**DESCRIPTION:**  
Ltr re our 6-5-73 ltr & their 4-24- & 5-1-73 ltrs.....furnishing info re the uncontrolled releases of radioactive liquids....W/Attached Fig 1 & 2 ....& Tables 1 & 2.

**PLANT NAME:** H. B. Robinson Unit No. 2

H. B. ROBINSON UNIT NO. 2  
 DOCKET NO. 50-261  
LICENSE NO. DPR-23

FIGURE 1

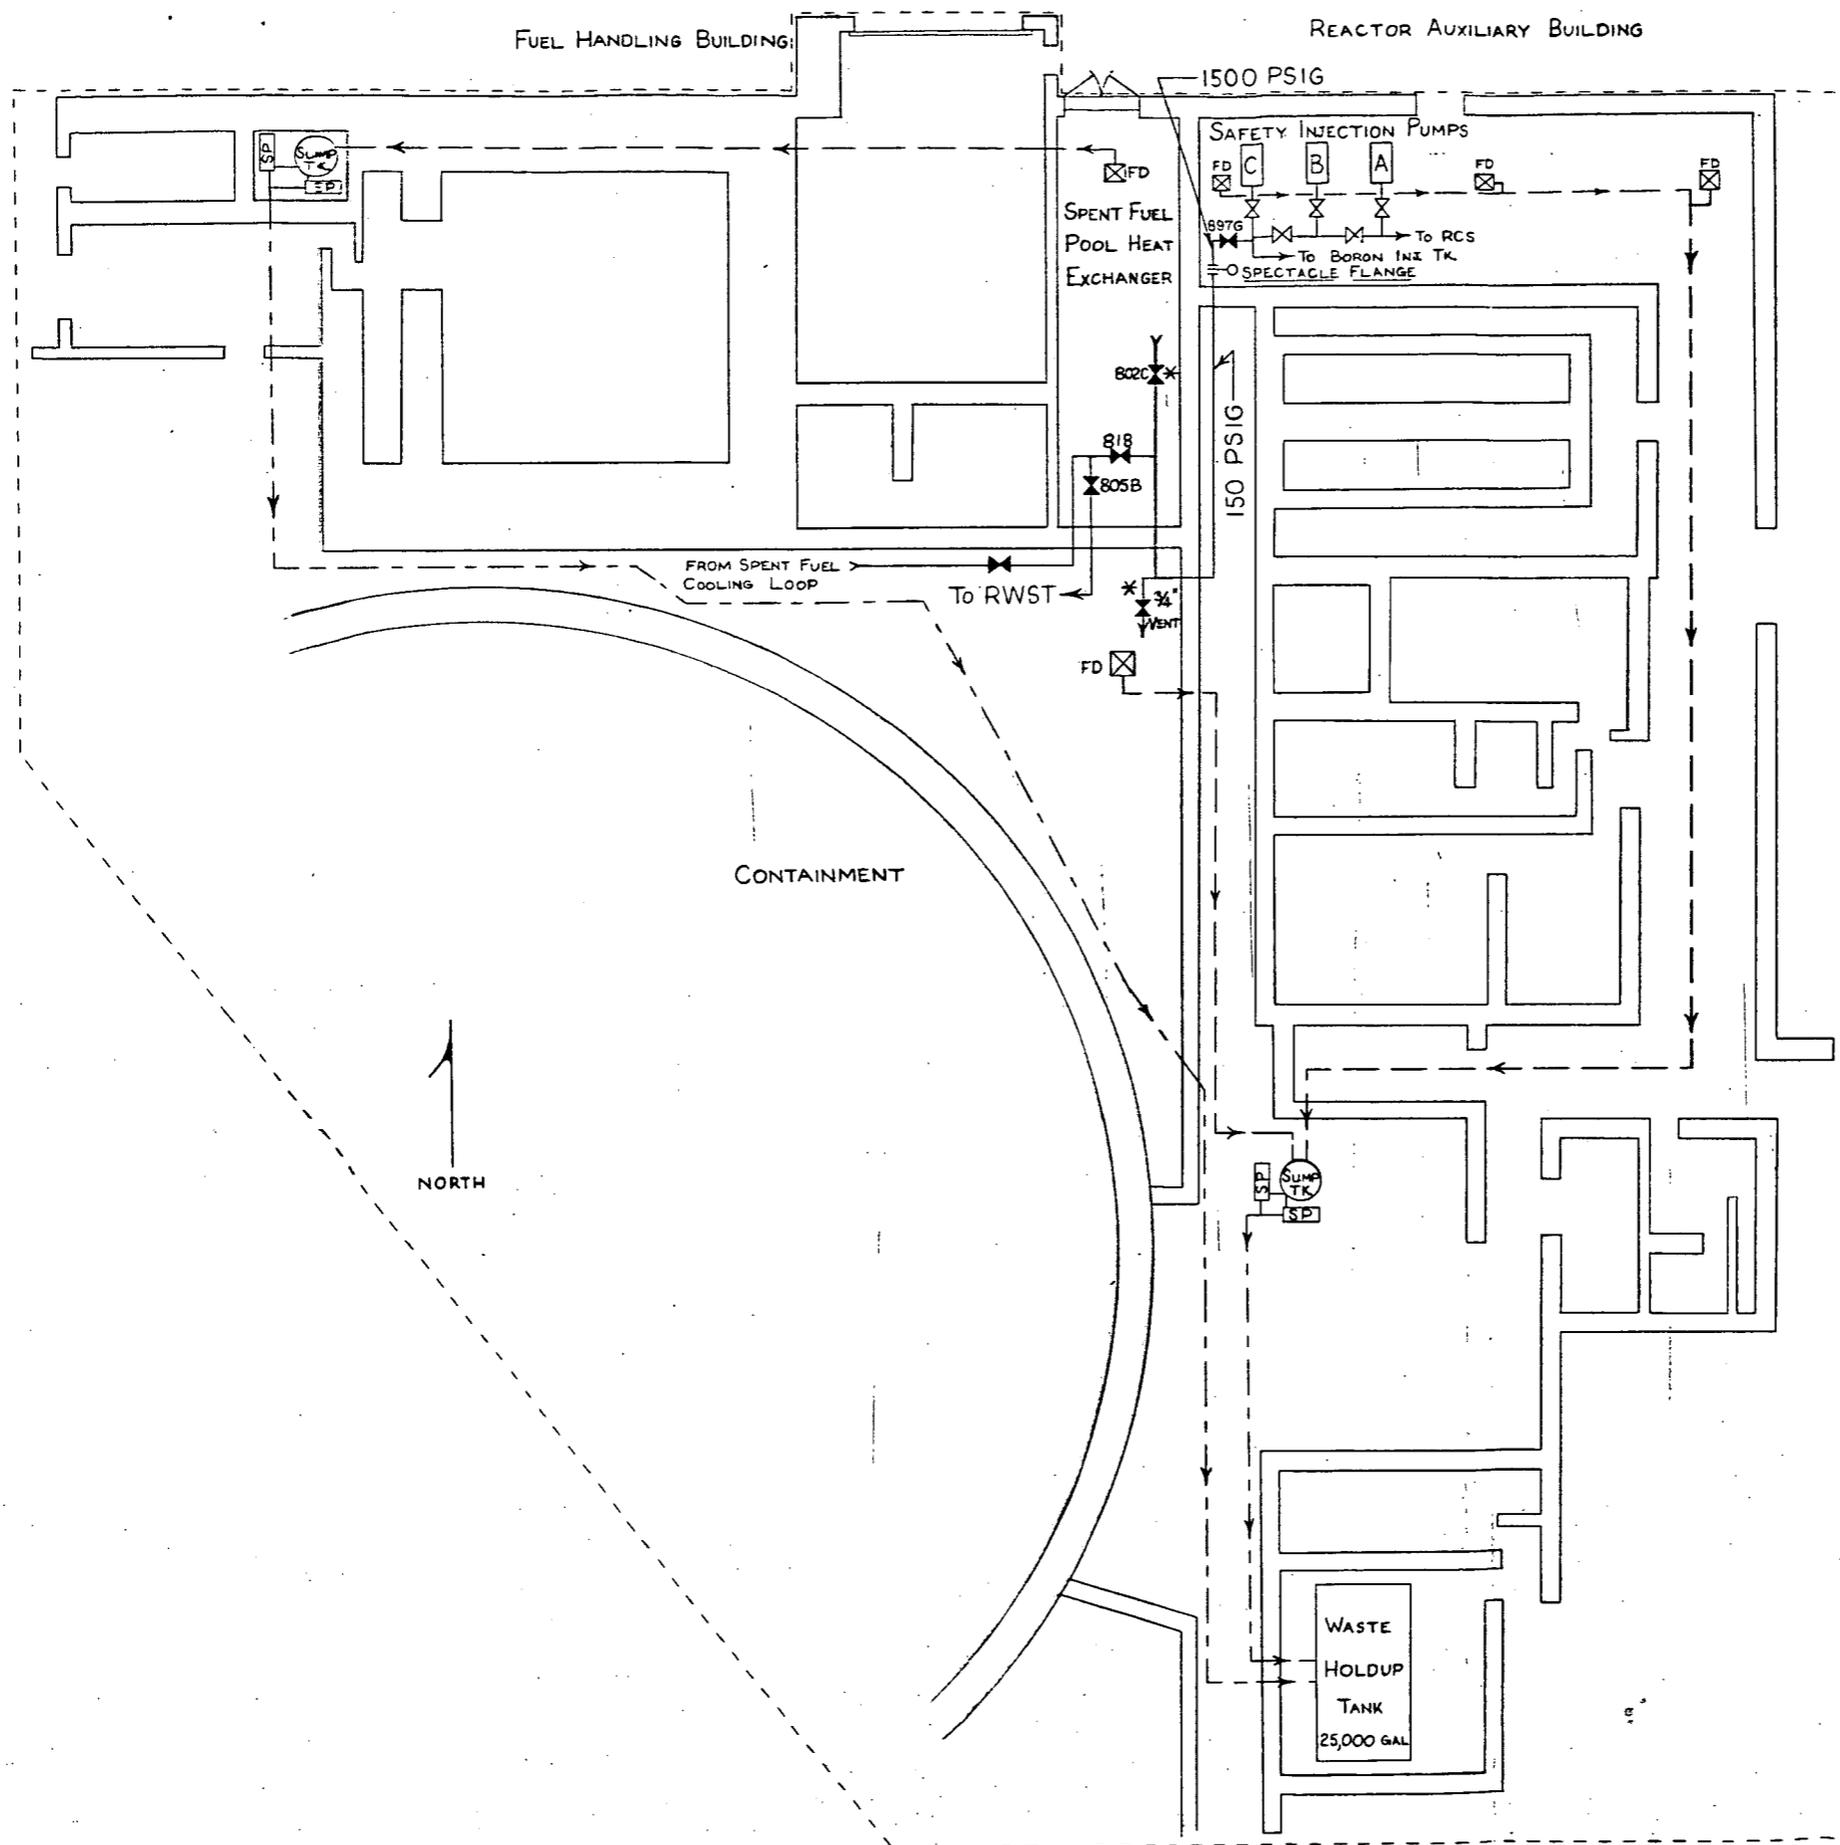
Item 1. For the April 10 abnormal occurrence, provide a schematic diagram of the system in which the leak occurred and of related systems. Identify on the schematic diagram: design pressures, the valve which leaked, the safety injection pump which was running, the spectacle flange and any other flanges of interest. Describe the need for: interconnection of the systems involved, the spectacle flange and any similar or related flanges, and pressure relief valves and appropriate routing of their effluents.

Item 2. For spaces containing the systems above, describe in detail: their drainage, the location and volume of sumps, sump level sensors and alarms, and the divide between areas which drain to onsite and offsite sumps.

Response: Figure 1 gives a schematic representation of the system in question. As shown, the design pressure of the safety injection system is 1500 psig up to the spectacle flange with the design pressure of the spent fuel clean-up system being 150 psig. Safety Injection Pump A was running at the time of the incident with leakage occurring at valve 802C and the 3/4 inch vent valve.

The purpose of the spectacle flange is to act as a protective device to prevent overpressurization of the low pressure piping downstream of the flange. This would occur if the isolation valve (897G) leaked during operation of the safety injection pumps. No other flanges or relief valves are installed in the low pressure piping. This protection was not provided in the design of the plant as it was not anticipated that a test involving operation of the safety injection pumps would be required while the plant was in a refueling shutdown condition. A request for a change to the Technical Specifications to gain relief from such testing requirements has been requested.

The overpressurization causing the leakage was the result of the spectacle flange being in the open position, which is its normal orientation during refueling shutdown. The refueling period is the only time during which the flange would normally require such positioning.

Response: Leakage from the 3/4 inch vent valve flowed to the floor drain in that area and subsequently to the auxiliary building sump tank (375 gal. capacity). Leakage from valve 802C flowed to the floor drain in that area and then to the fuel handling building sump tank (375 gal. capacity), however, some of the water in this area overflowed a concrete sill at the door. Each of these sumps are serviced by two 20 gpm sump pumps which transfer the water to the waste hold-up tank. Both sump tanks have the following controls and alarms which annunciate on the WDSBR panel and on the RTGB:

The divide between areas which drain to onsite and offsite sumps is shown on Figure 1.

FIGURE 2

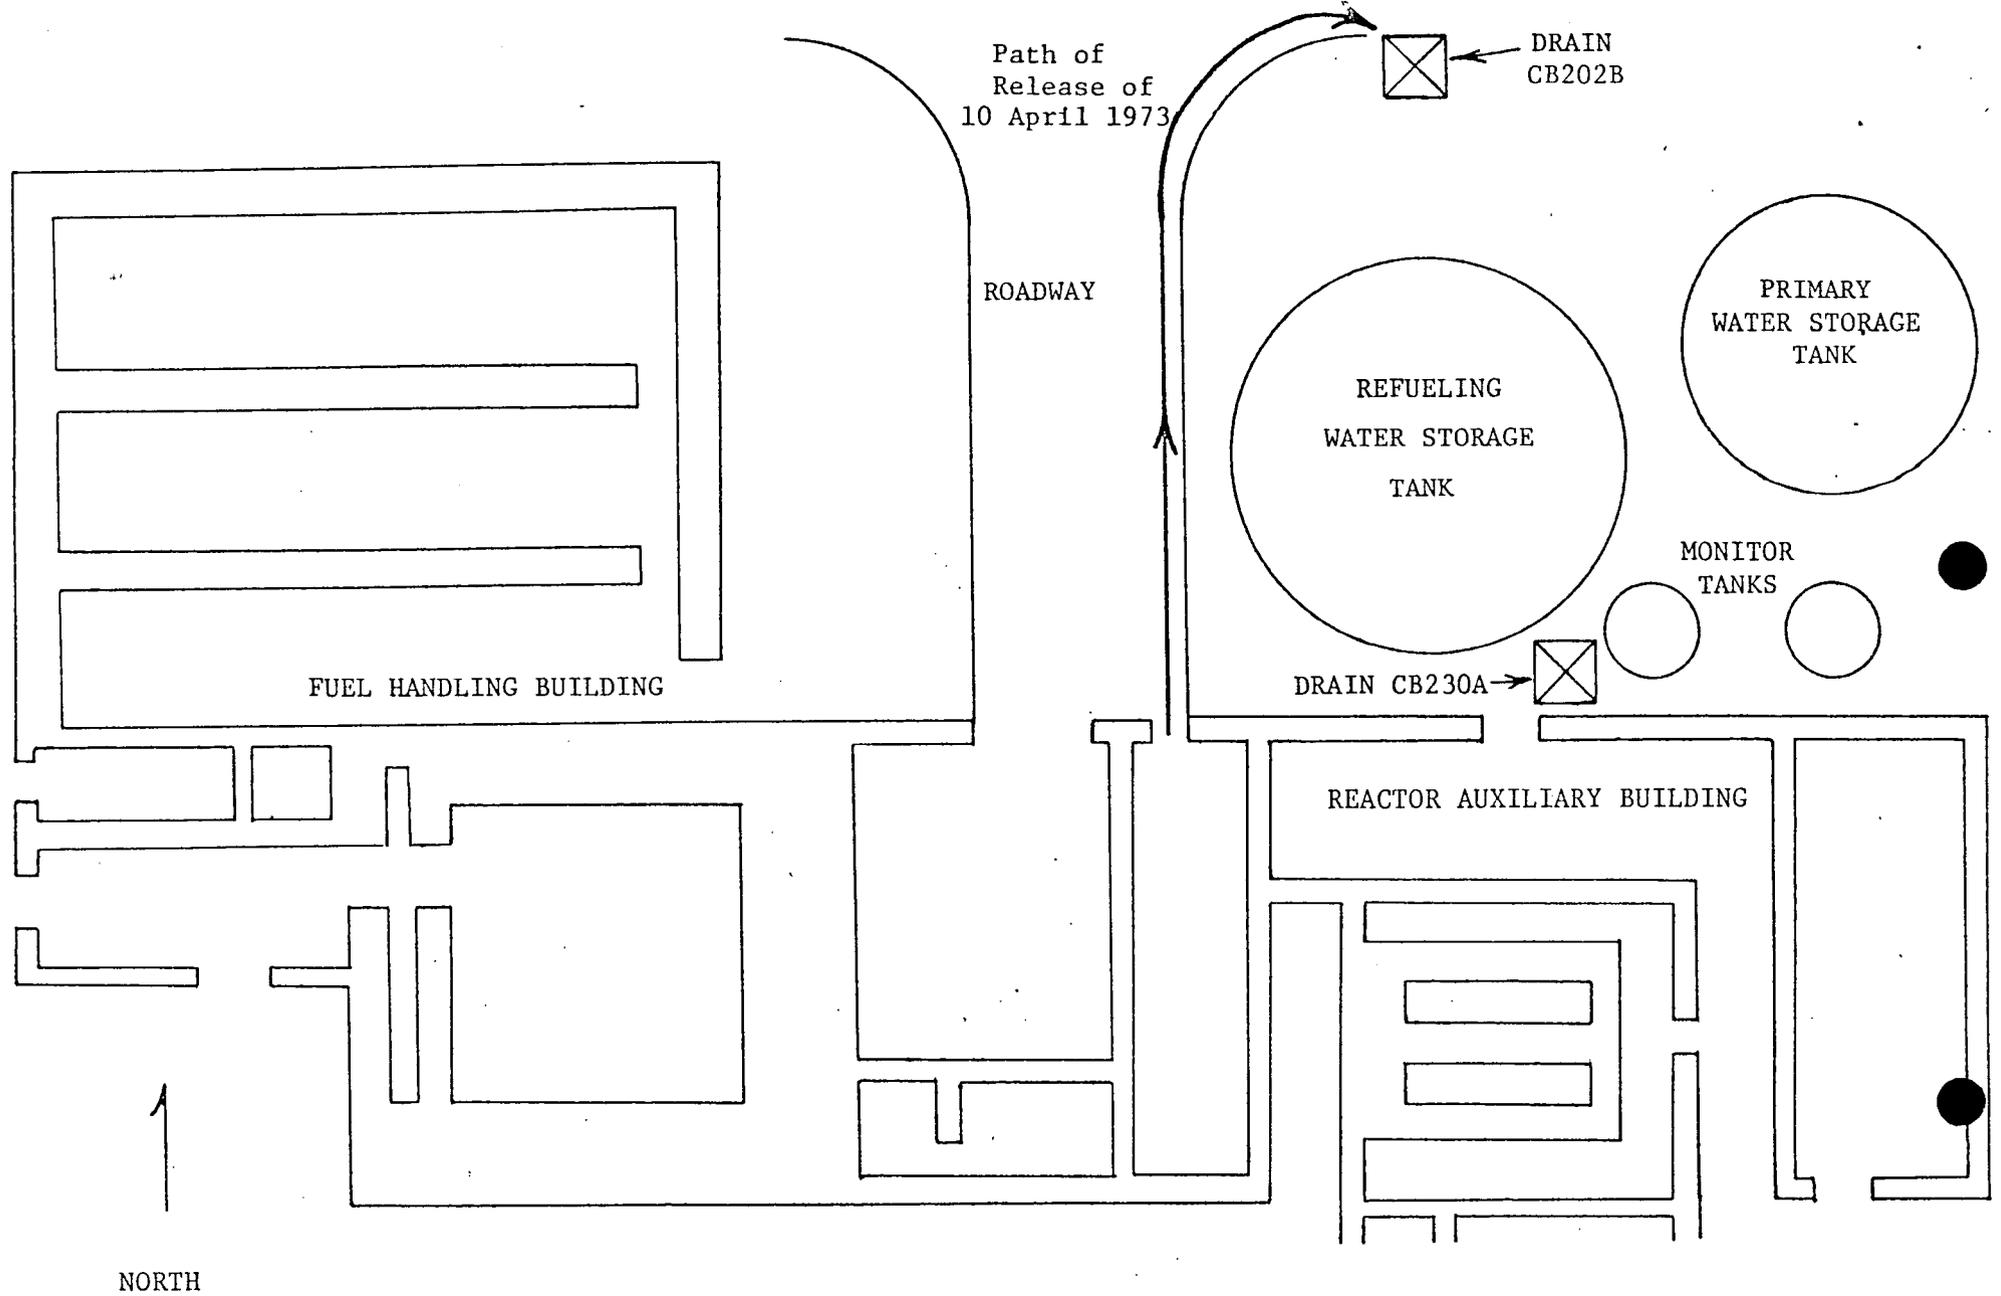
Item 3. For the abnormal occurrences of April 10 and 23, identify in detail the path of the effluent from the source of leakage to Black Creek. Indicate the points at which the effluent crossed restricted area boundaries, the fence line, and the site boundary. Identify the points at which dilution occurred and how the amount of dilution was estimated. Estimate the fraction of MPC (10 CFR Part 20, Appendix B, Table II, Column 2) at each point. Provide the results of soil samples taken from the effluent path.

Item 4. Identify all other tanks and systems which would release radioactive liquid from the site in the event of overflow or leakage.

Response: The April 10 incident occurred in the spent fuel pool heat exchanger area. Water spilled into this area, overflowed a concrete sill at the door on the north side of the area and flowed into drain CB202B (Figure 2). Overflow from the refueling water storage tank on April 23 flowed directly into drain CB230A. From there the water flowed through drain piping to drain CB202B, which is the point where the water from the April 10 incident entered the drainage system. In both incidents the leakage was directed underground to the drainage ditch south of the facility passing drains CB203, CB204, CB7, CB8, CB9, CB14, CB15 and CB226.

Response: Figure 2 shows the location of all tanks which are located outside the plant buildings that could potentially contain radioactive material. These tanks include the primary water storage tank (PWST), the chemical and volume control system monitor tanks "A" and "B" (MT), and the refueling water storage tank (RWST).
